D070442-v3

## Request to increase the size of the cutouts in the HLTS gussets. or move gussets

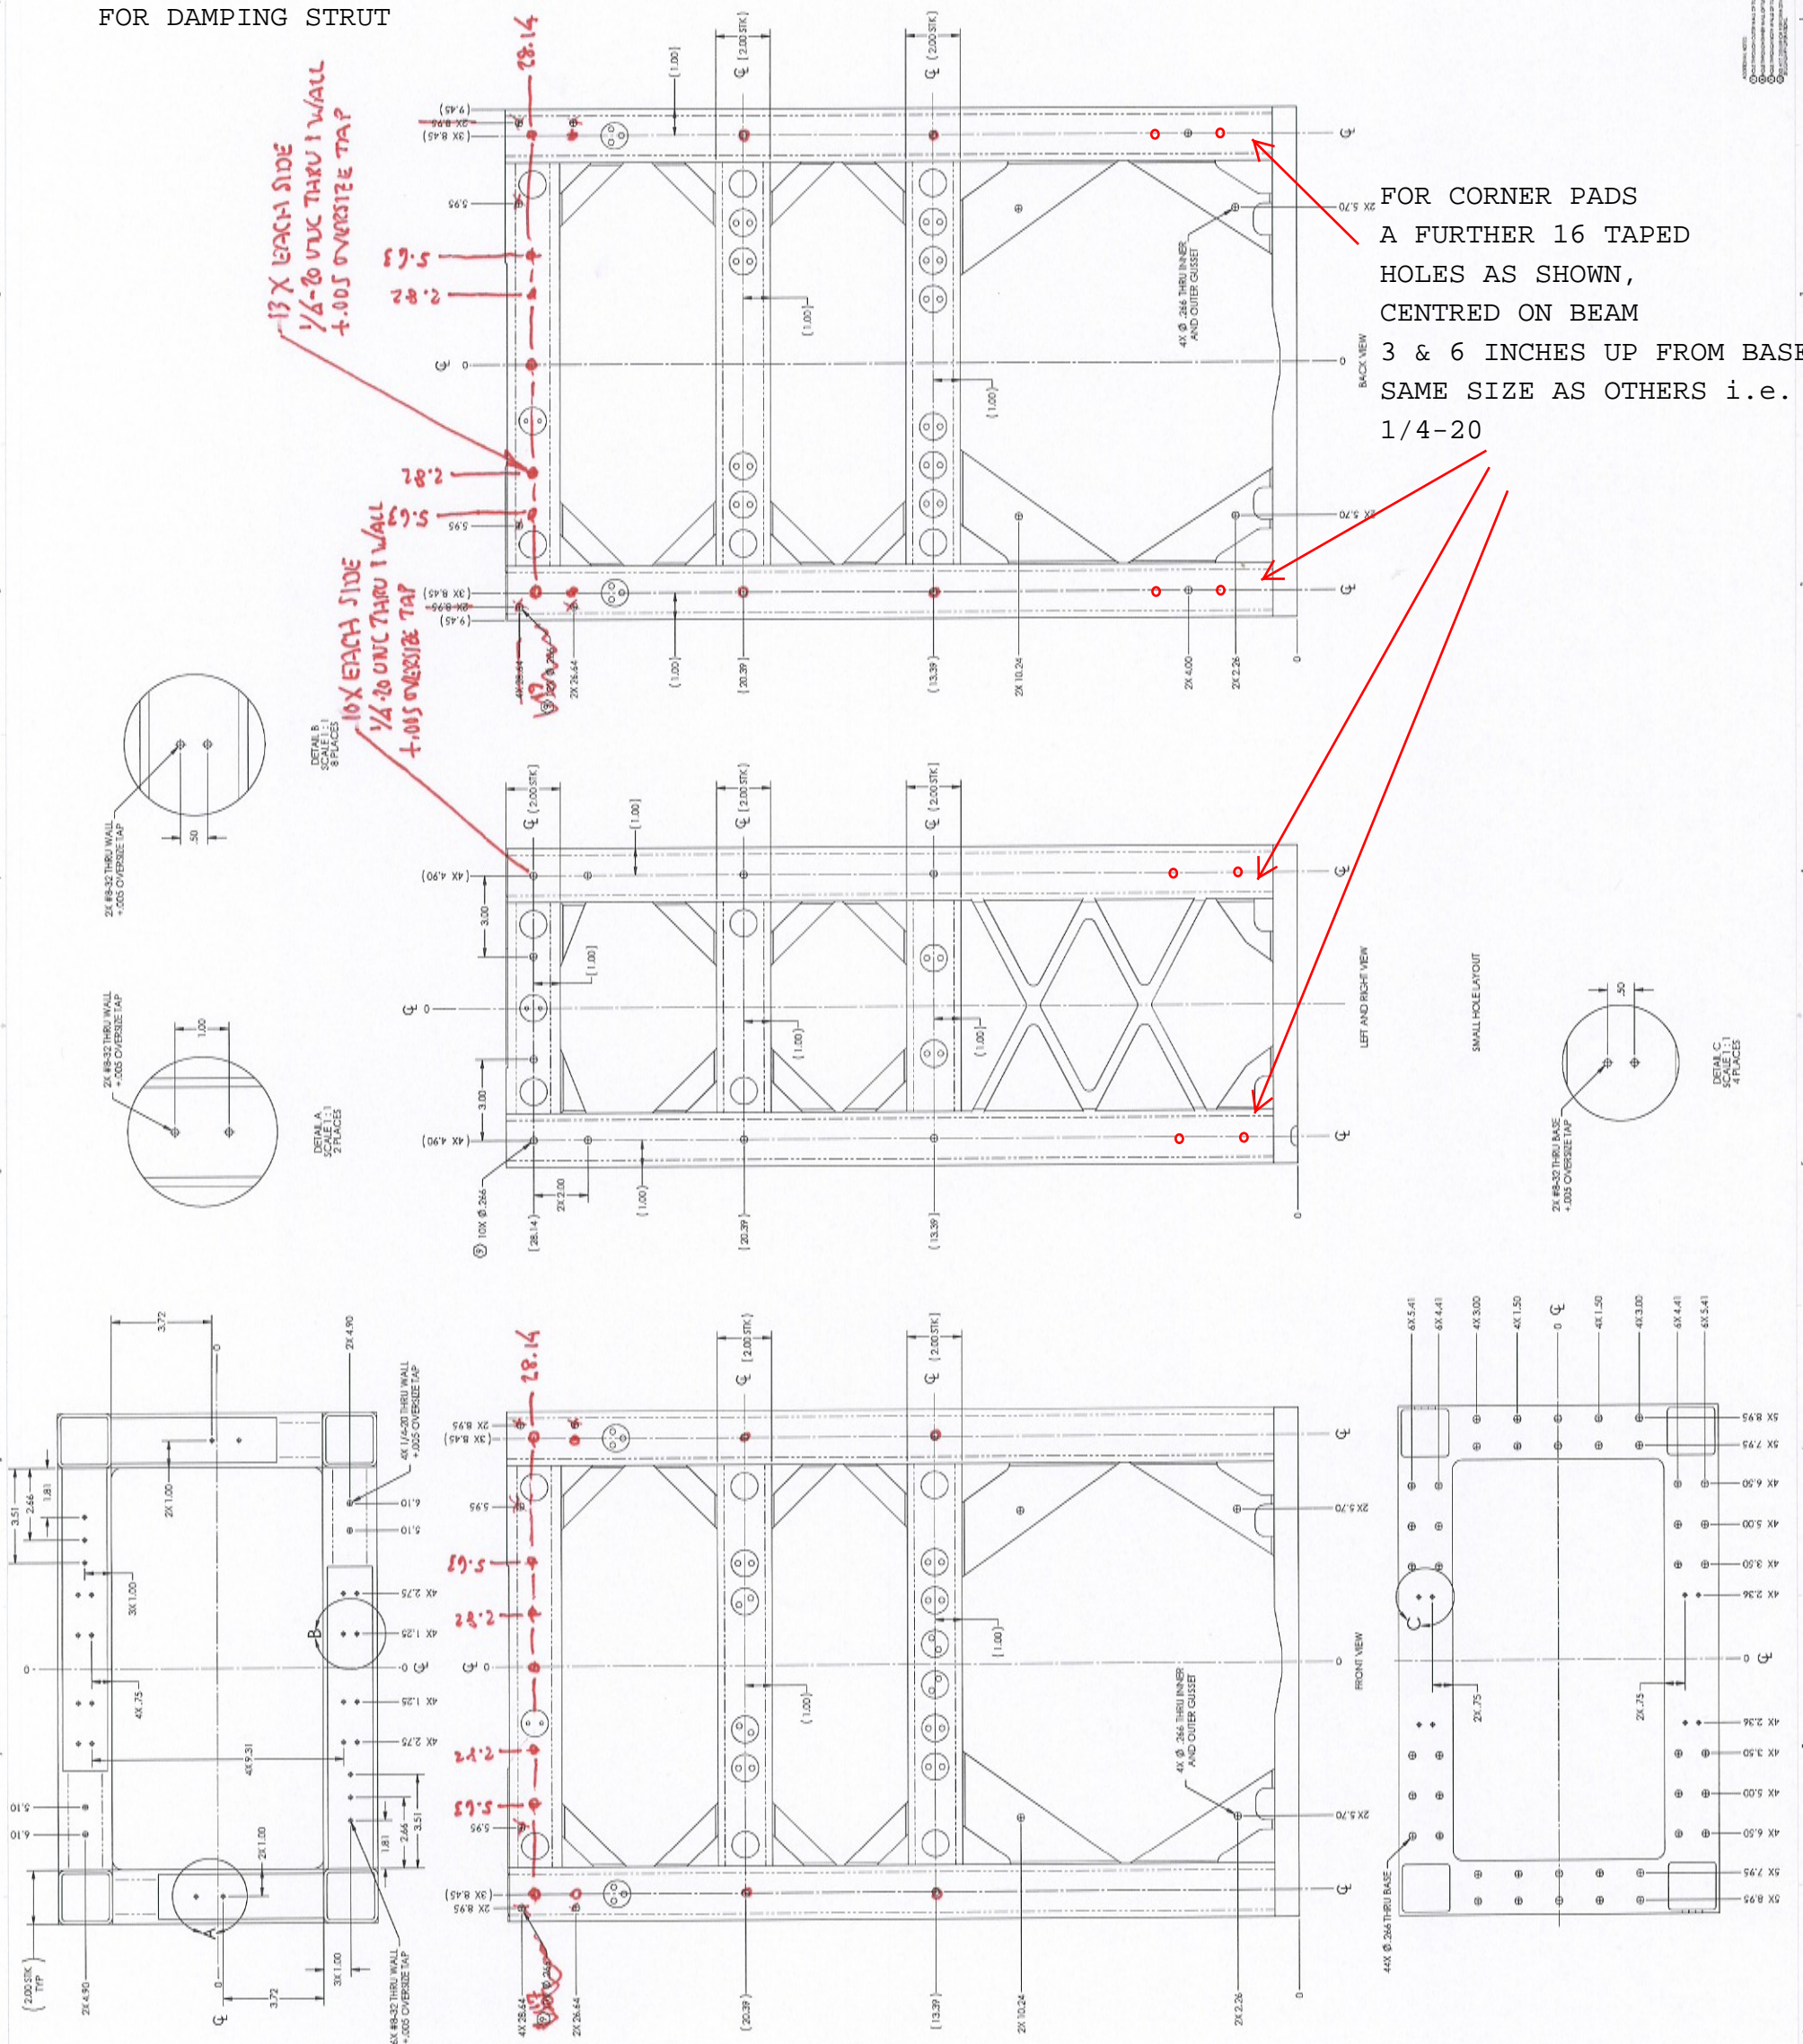
FOR CORNER PADS  
A FURTHER 16 TAPED  
HOLES AS SHOWN,  
CENTRED ON BEAM  
3 & 6 INCHES UP FROM BASE,  
SAME SIZE AS OTHERS i.e.  
1/4-20

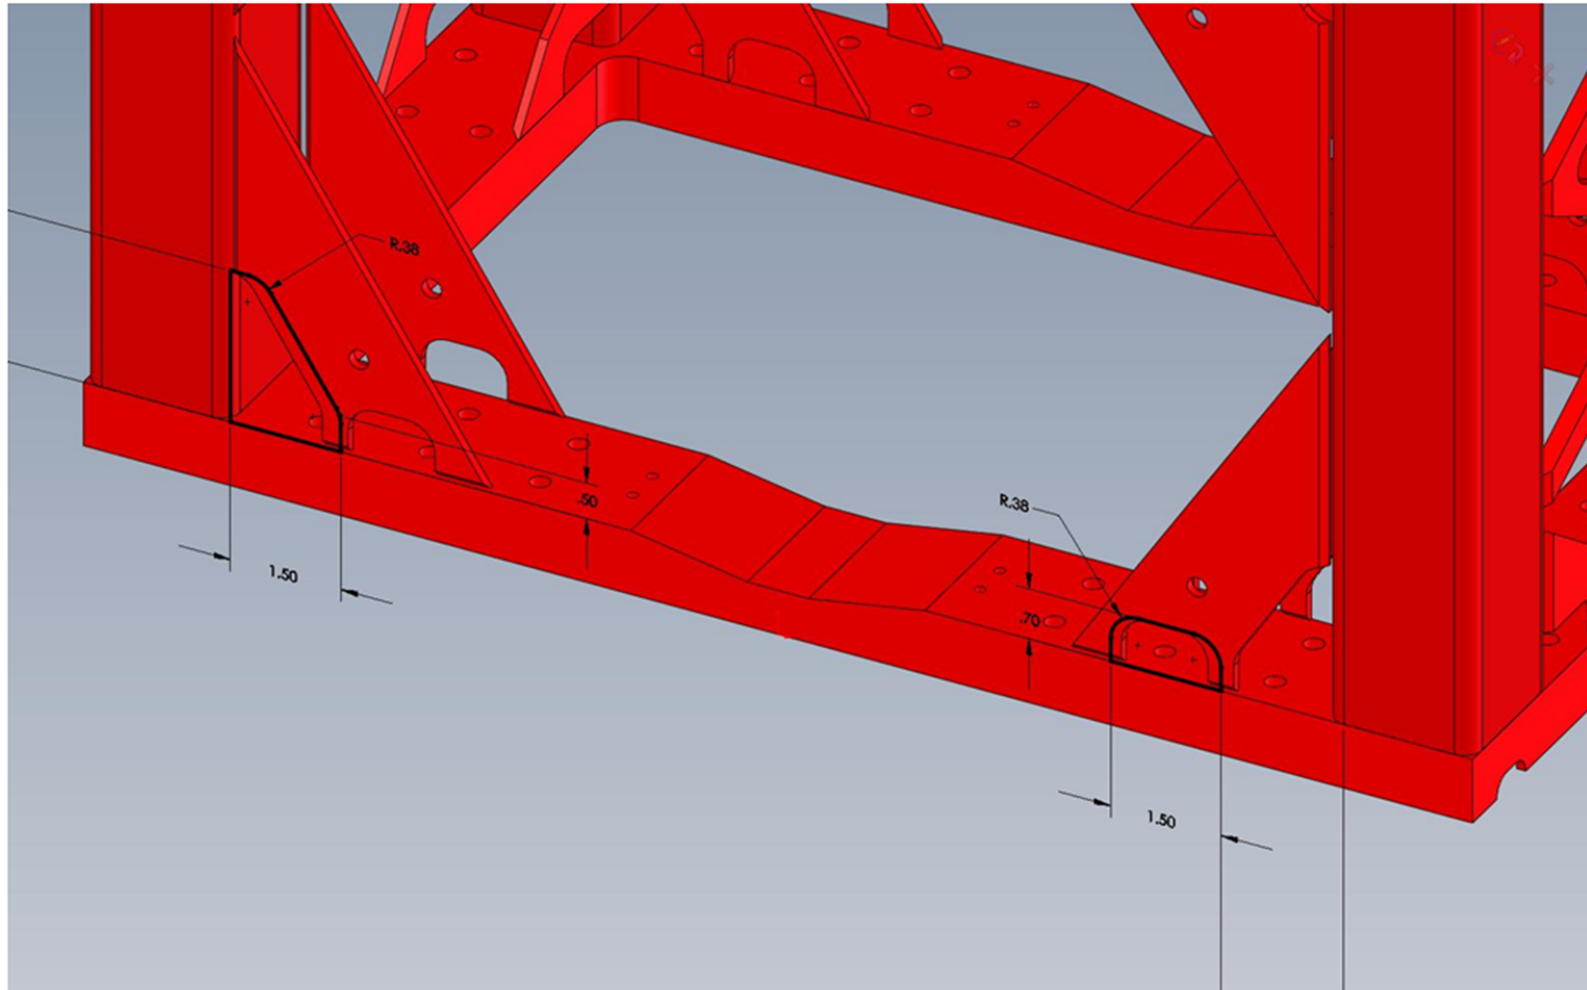
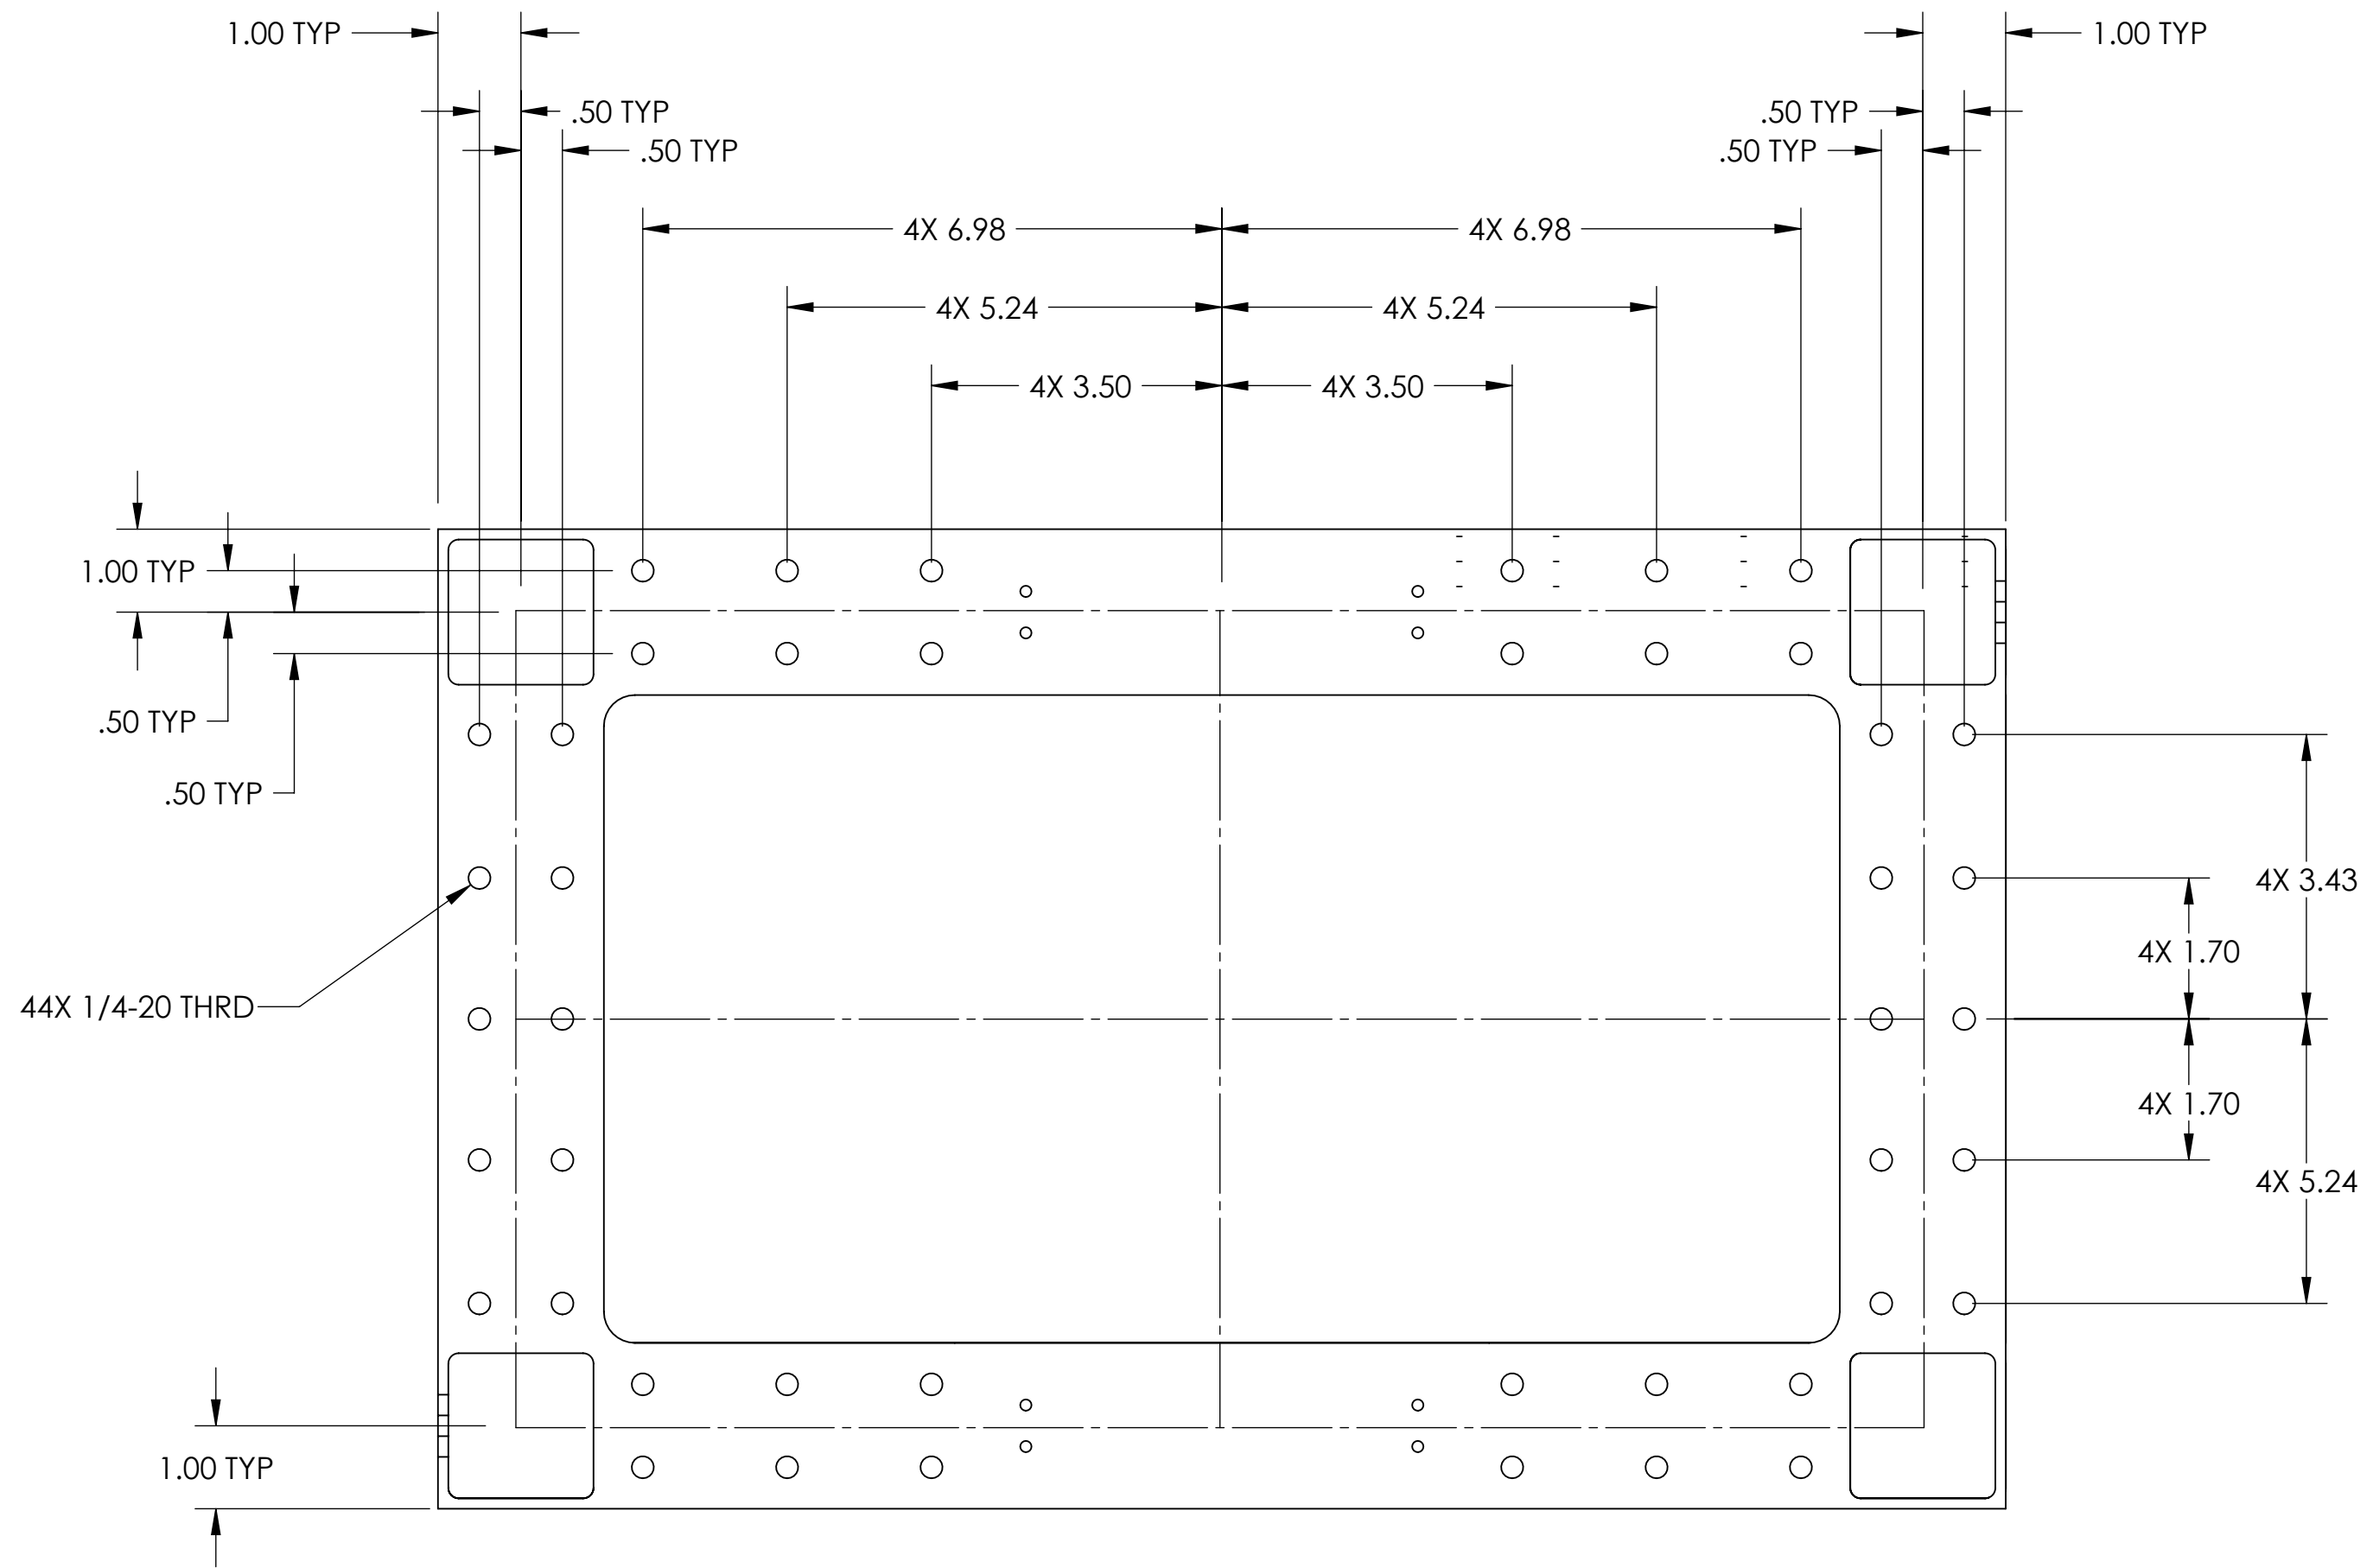
Request to increase the size of the cutouts in the gussets of HLTS to provide more clearance and allow increased range of motion to clamps when securing the HLTS to the HAM tables.

The sketch above describes an increase in length of the cutouts in features. Dimensions shown are arbitrary examples. Cutout size will be determined by the available space and gusset configuration.
